Town of Parker Community Development Department
Development Review Division
Attention: **Amber Wood Hicken**

Application Type: **Site Plan – Non-Residential**
Status: **First Referral**
Application Name: Parker & Pine F1 L1 - In-n-Out Burger
Case/AP#: **SP22-143**
Referral Received: January 17, 2023
Comments Due: February 7, 2023

Review date: **January 31, 2023**
Plan reviewer: **Randall L. Capra**, rcapra@parkeronline.org
Phone: 303.805.3163

TOWN OF PARKER - FIRE/LIFE SAFETY:

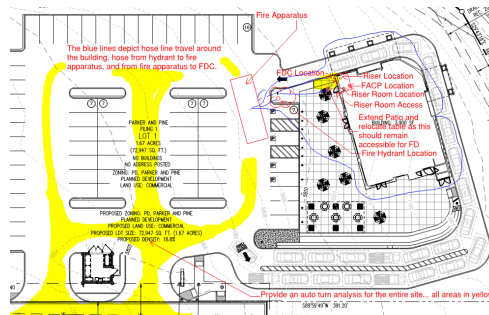
8. The Town of Parker requires that fire apparatus access roads meet the clear-width and weight-bearing standards of the jurisdiction in which the project is located. Roadways shall be designed to support the imposed weight of fire apparatus, 30-ton, two axle and 40-ton three, axle vehicles. An unimpeded clear width of 20-feet shall be maintained at all times (though Planning and Zoning requirements may require a minimum of 24 feet). Where building exceed 30 feet in height, a fire department access is required to be 26 feet in width. As such, any location where parked vehicles would obstruct this clear width requirement will require “NO PARKING – FIRE LANE” signage. *This signage shall be red on white. Update design criteria has been provided at the end of this document; ensure compliance when resubmitting.*
